REMARKS

FIG. 5

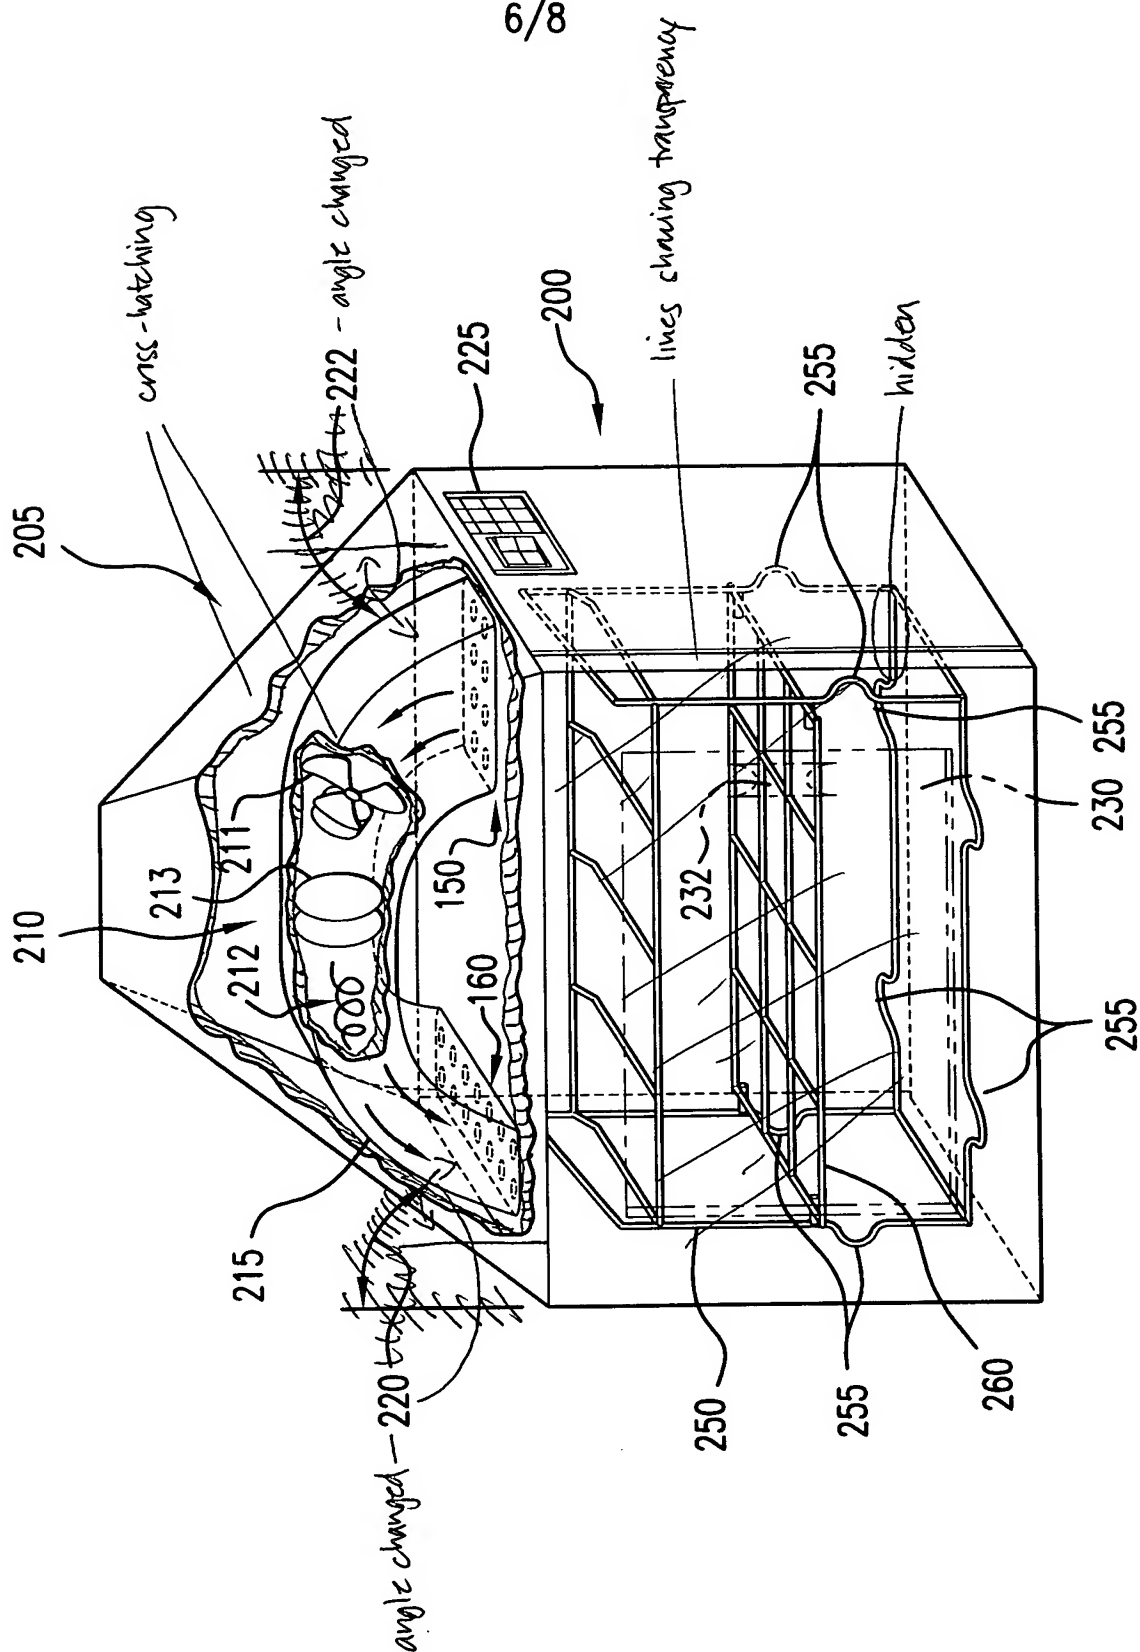
The drawings were objected to on page 2 of the Office Action because Figure 5 allegedly does not use the proper cross-hatching. Figure 5 has been amended to include proper cross-hatching. Figure 5 has also been amended as follows. First, the angles 220 and 222 have been amended to refer to the angle from the heating system to the adjacent vertical wall member, as is stated in the Specification at page 33, lines 26-29. The bottom right portion of the support member 250 has also been amended to clarify that it is hidden from view. Finally, lines showing the transparency of at least one wall have been added, the optional, but preferable transparency of the wall noted in the Specification at page 11, lines 31-32. A copy of FIG. 5 with redlining showing these changes, along with a revised FIG. 5 incorporating the changes, are submitted herewith. Accordingly, Applicants respectfully request that the objection to the drawings be reconsidered and withdrawn.
